# EXPERT TRANSPORT MEMORANDUM

## RFI RESPONSE - SECTION 2.5: Alps 2 Ocean Cycleway: Construction Traffic Safety Assessment

Project	The Point Solar Farm
Prepared by	Renewable Engineering Group (REG)
Prepared for	Far North Solar Farm Limited (FNSF)
Report No.	REG/TIA001/ThePoint01 — Supplementary Memo
Subject	RFI Response 2.5 — Alps 2 Ocean Cycleway: Construction Traffic Safety Assessment
Date	28 <sup>th</sup> April 2026

Figure 1.0 — Access Route Context: FNSF Construction Access vs Allan/Fordyce Legal Access

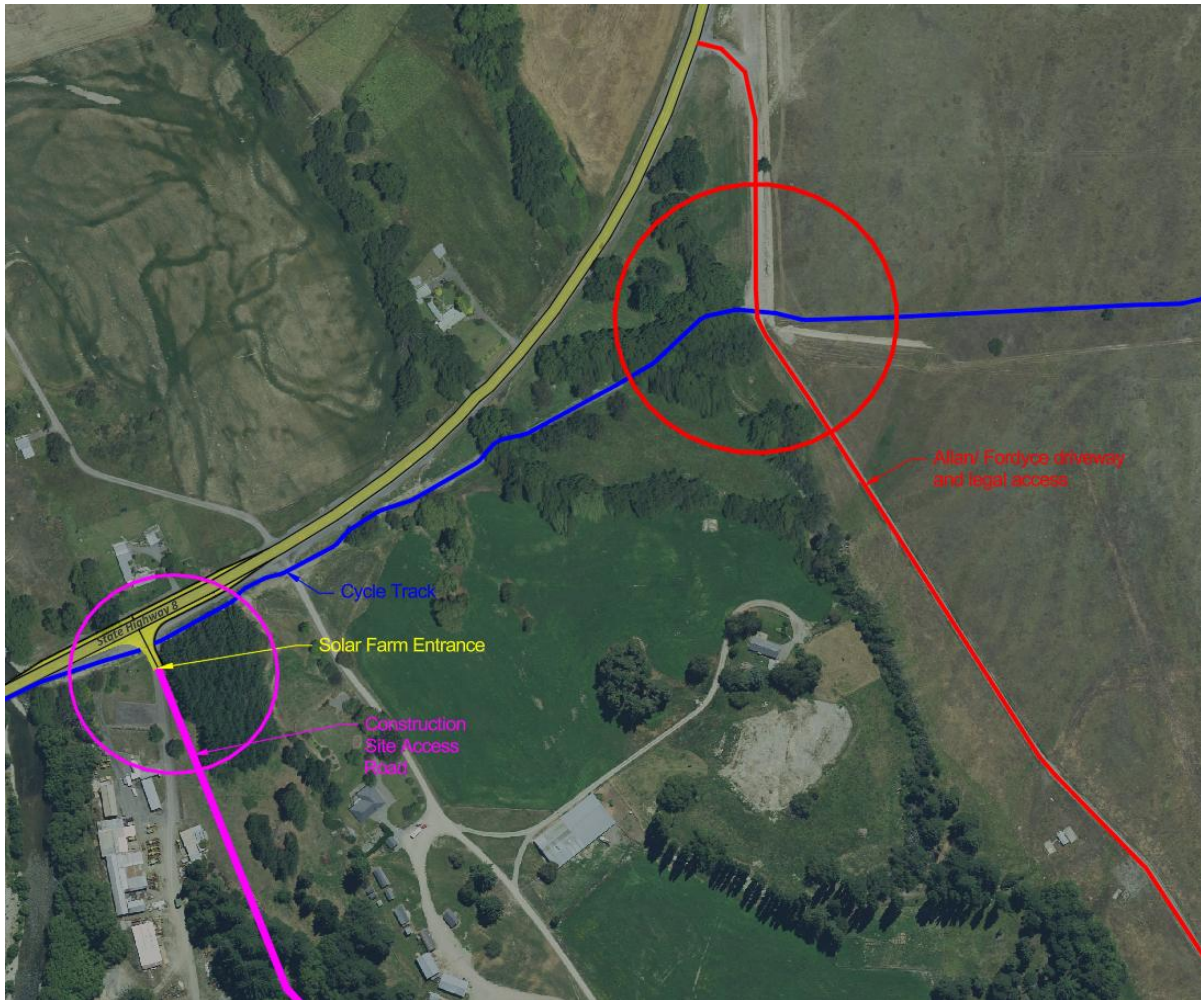
The Expert Panel, having regard to submissions from Mr Allan and Ms Fordyce, has requested an expert traffic assessment addressing the potential implications of the proposal for users of the Alps 2 Ocean Cycleway and other users of the shared access track to the solar farm (RFI Section 2.5(a)).

A key clarification is necessary at the outset: the construction access for The Point Solar Farm and the Allan/Fordyce legal access are entirely separate routes. FNSF construction traffic will not use the Allan/Fordyce driveway at any point during the construction phase. This distinction, which appears to have been a source of confusion in the submitter's concerns, is addressed in detail in Section 2 below and illustrated in Figures 1 and 2.

FNSF construction traffic has no interaction with the Allan/Fordyce driveway. The two access routes are physically separate and serve entirely different purposes.

As shown in Figure 1, the Allan/Fordyce driveway (red) independently crosses the A2O Cycle Track at a separate location northeast of the Solar Farm Entrance (red circle). This crossing is a pre-existing condition, Allan/Fordyce vehicles already interact with Cycle Track users at this location as part of their normal residential and farming access, irrespective of the proposed solar farm.

The A20 Cycle Track (shown in blue on Figures 1 and 2) runs along the SH8 corridor and crosses the FNSF Construction Site Access Road at a point immediately before the T-intersection with SH8 (pink circle, Figure 1). This is the only interaction between FNSF construction traffic and the Cycle Track.
